RE: Commissioner's Questions

We refer to your email of 31st October 2018 and the list of questions from one of the Commissioners for some of our witnesses. We have passed the questions on to those witnesses and provide their responses below.

Private Properties Within Air Quality 220 m Setback

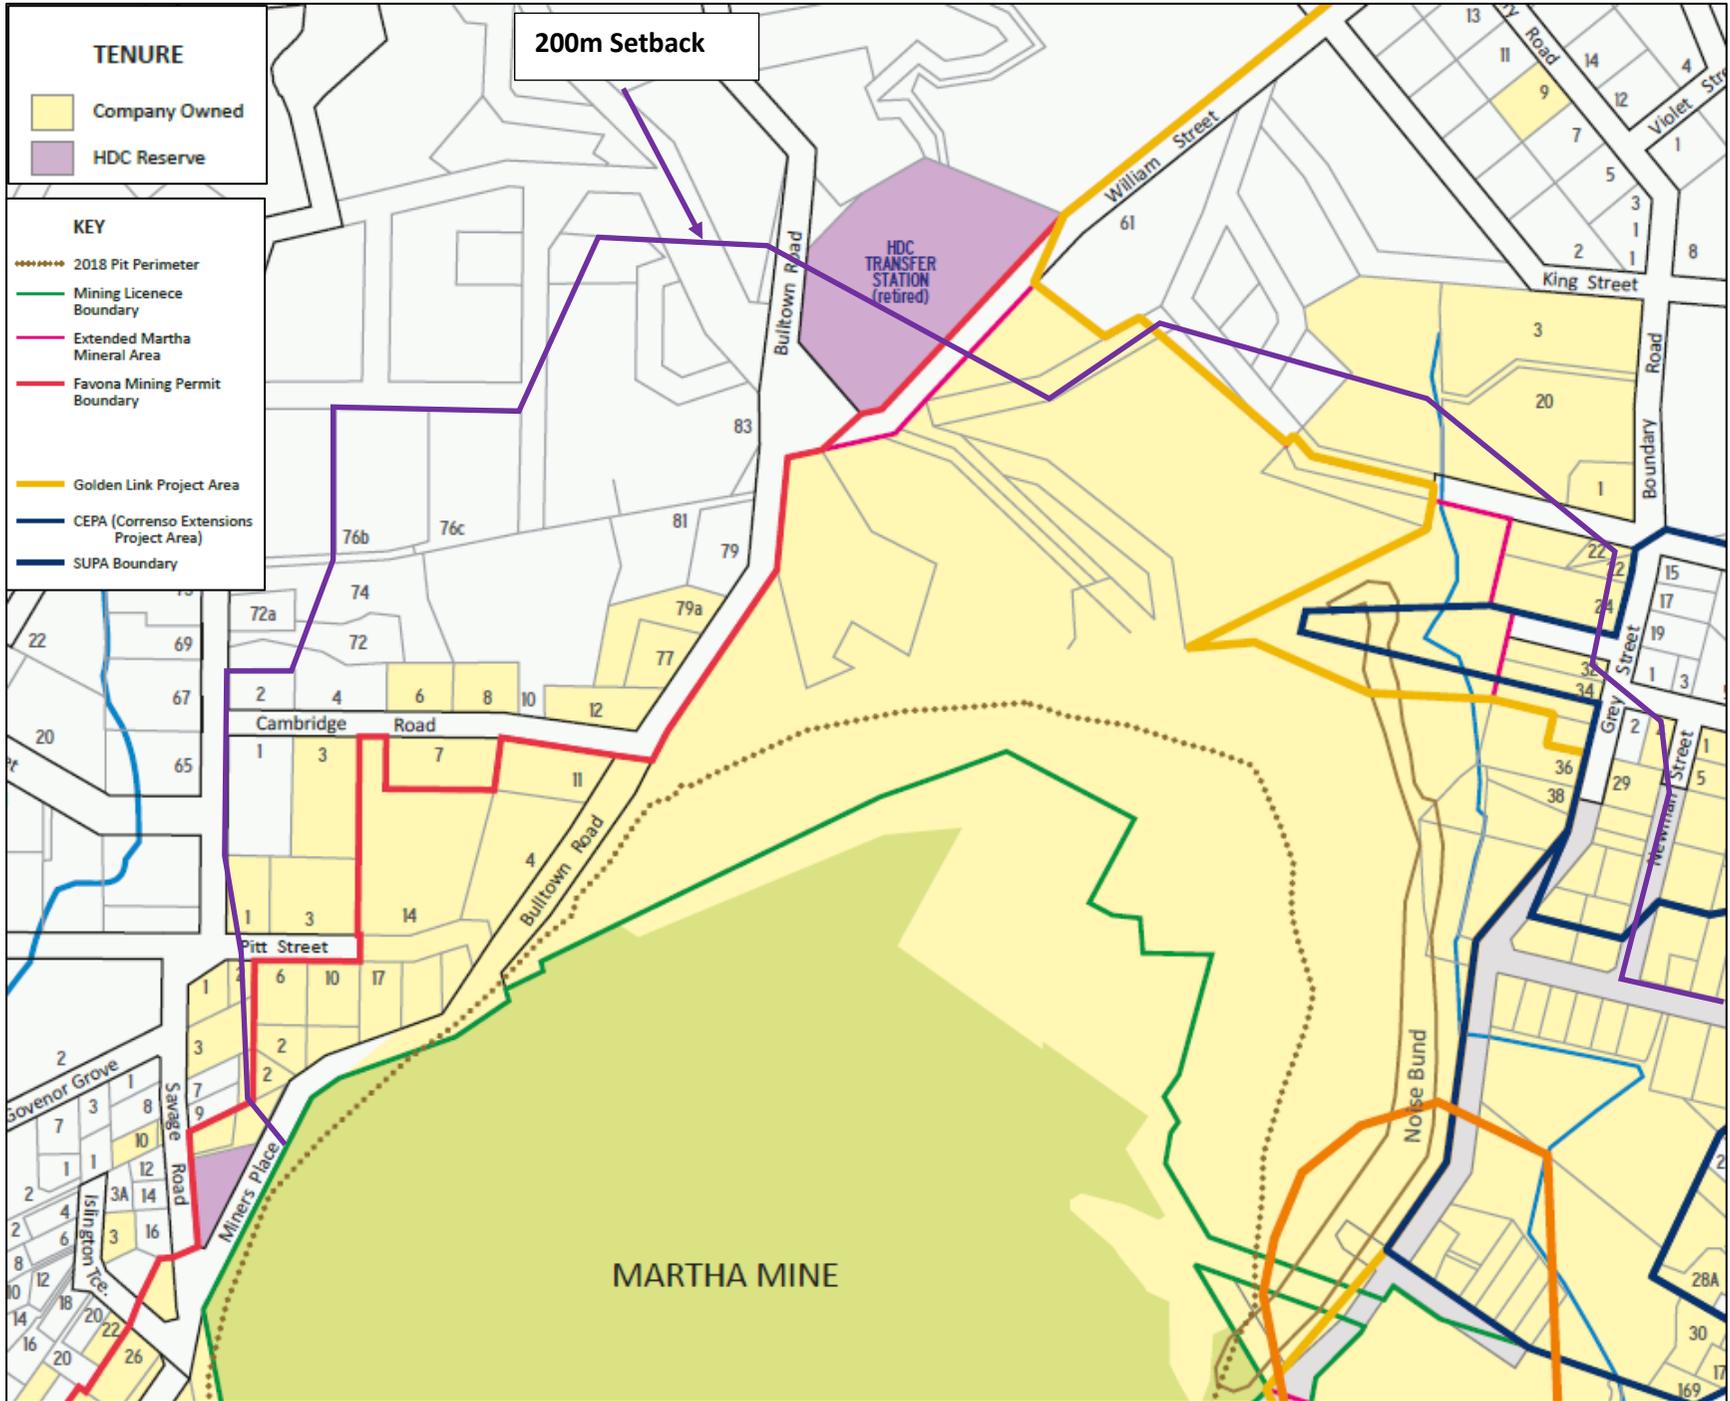
Appendix 2 *Which of the residential properties within the 200m set back boundary are not owned by OGNZL?*

Refer Attachment 1.
